Planning Application Ref: AW/71/18/HH

Location: 36 Kingsway, Aldwick

Description of works: Demolition of existing ground floor extensions to front of property, construction of a single storey rear extension and reworking of existing external hard and soft landscaping. This application affects the character and appearance of the Craigweil House Conservation Area.

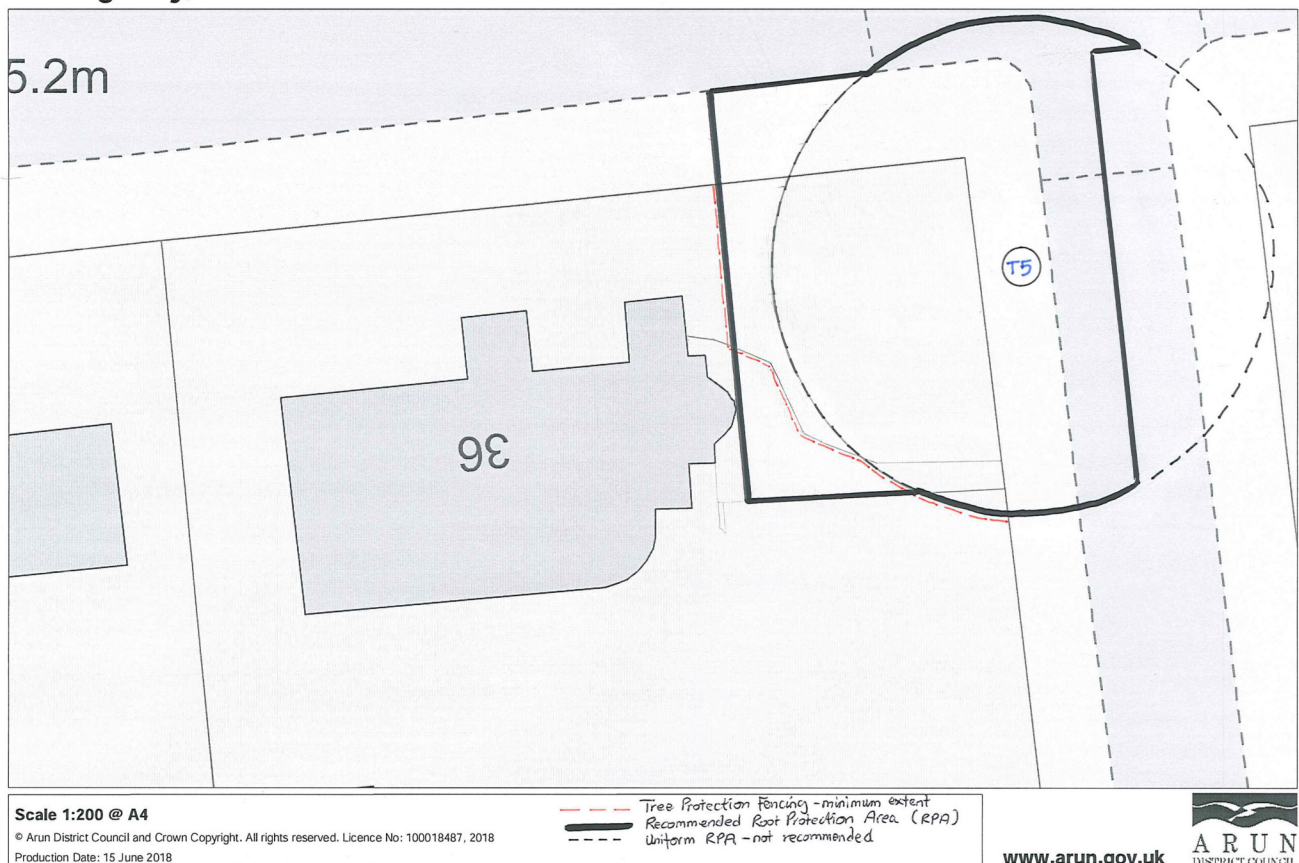
- In respect of T5, large roots can be seen tracking for considerable distance alongside the kerb-edging in both directions and there is little if any evidence of root-related heave/disruption to the adjacent concrete formed carriageway surface. There is evidence of what seems likely to have been repair/servicing of underground utility apparatus in close proximity to the tree.

- As it stands, the location of the proposed second driveway access construction is likely to impact severely on the root system of T5 with damaging consequences, such that it could decline rapidly.

36 Kingsway, Aldwick

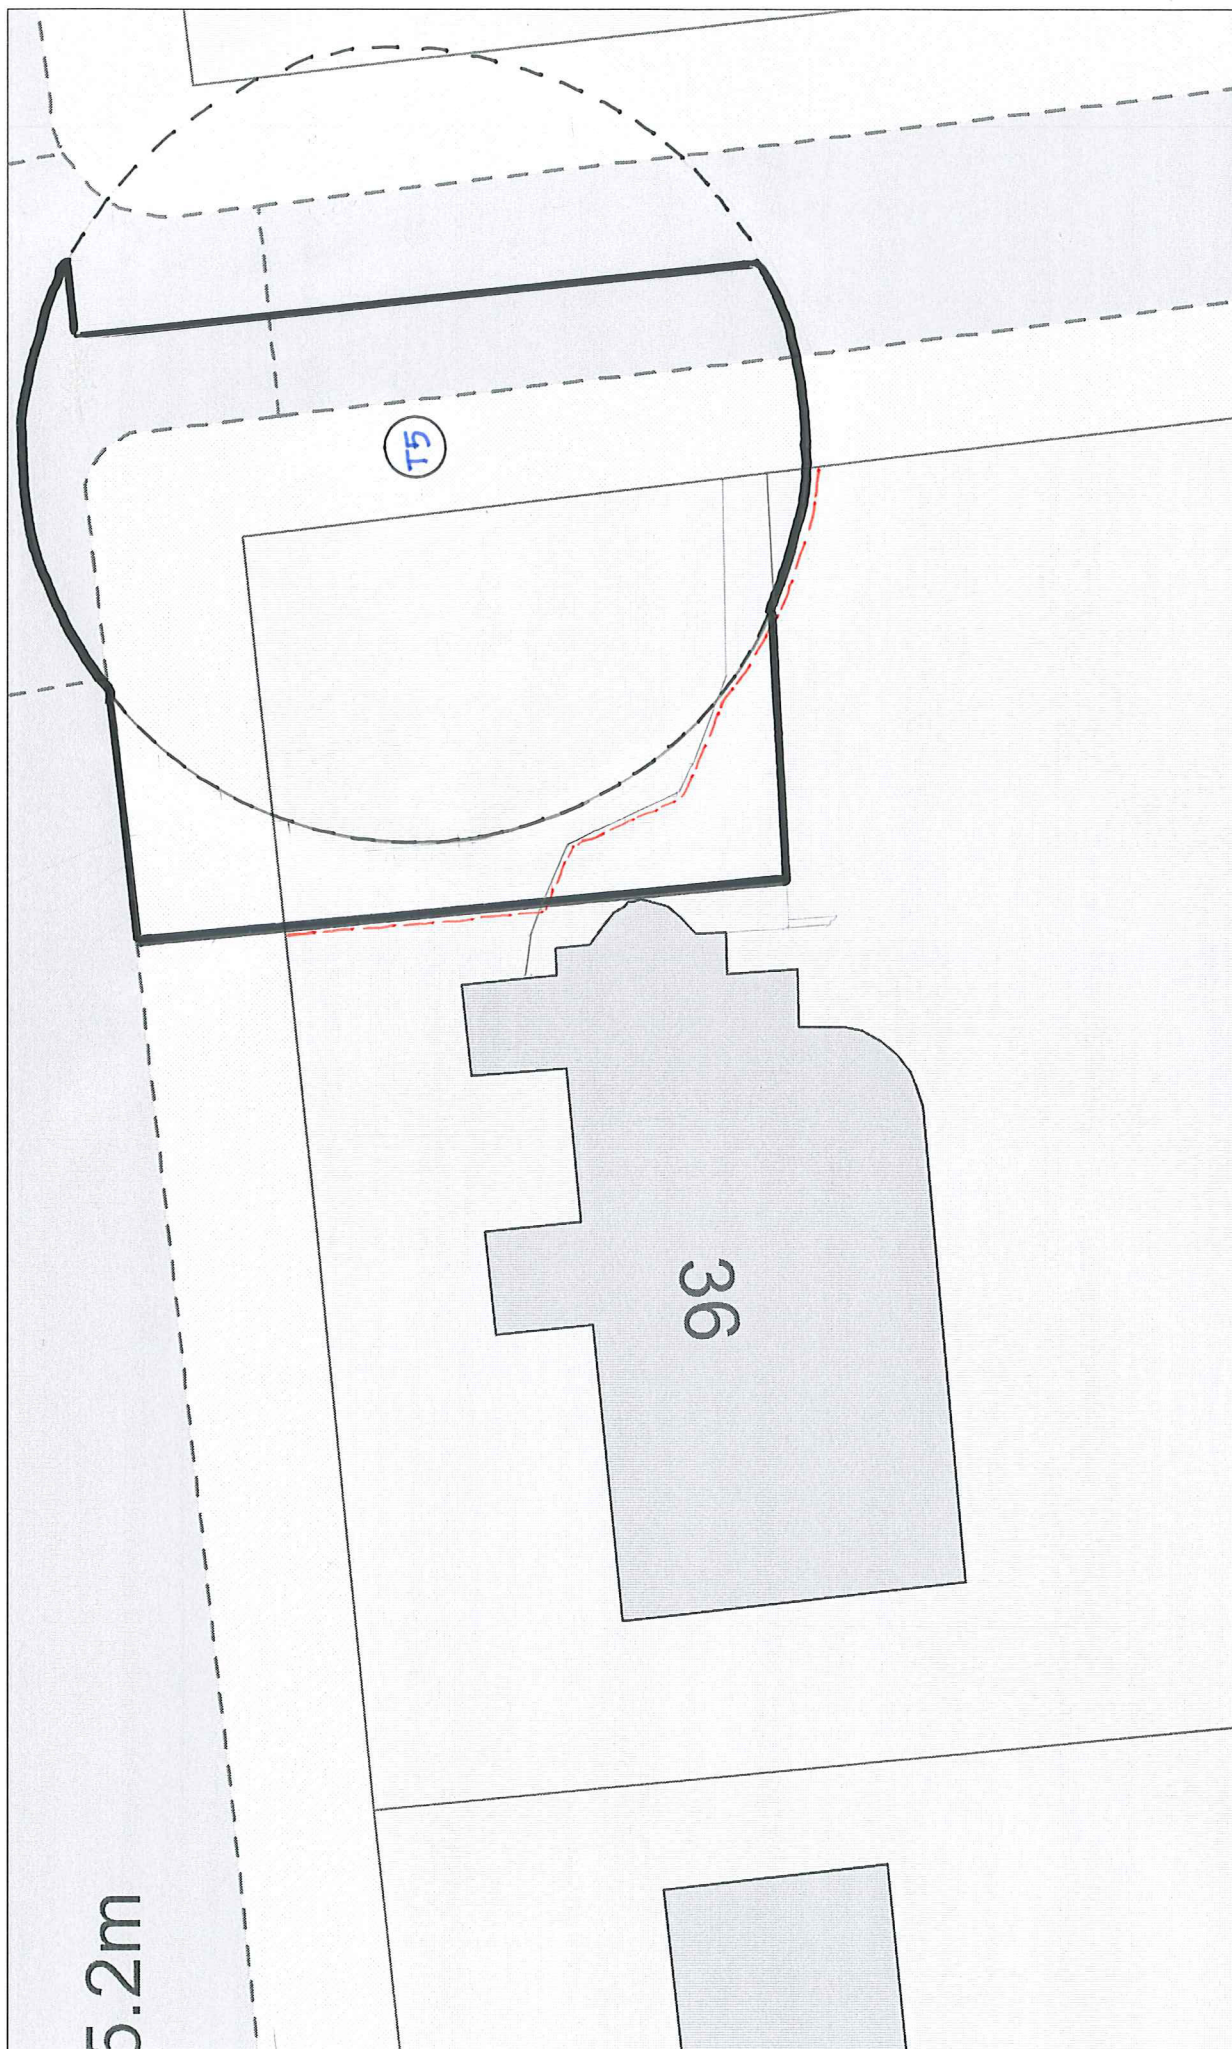
- I would need to see a revised and asymmetric RPA for T5 that adequately compensates for the impediment to root growth as described earlier, before I could consider lending this scheme my full approval. This will require the re-positioning of the second driveway access further west; an alternative 'No-dig' method of construction in the proposed position would demand ground level changes that are unlikely to be acceptable to the applicant.

- I attach an indicative plan showing the desired RPA outcome for T5 to be adopted in a revised tree protection plan drawing, which can better inform a design. If necessary, I would be happy to meet the applicant's agent to discuss the methodology and measurements that support this plan.

- Tree Protection Fencing - minimum extent
- Recommended Root Protection Area (RPA)
- Uniform RPA - not recommended
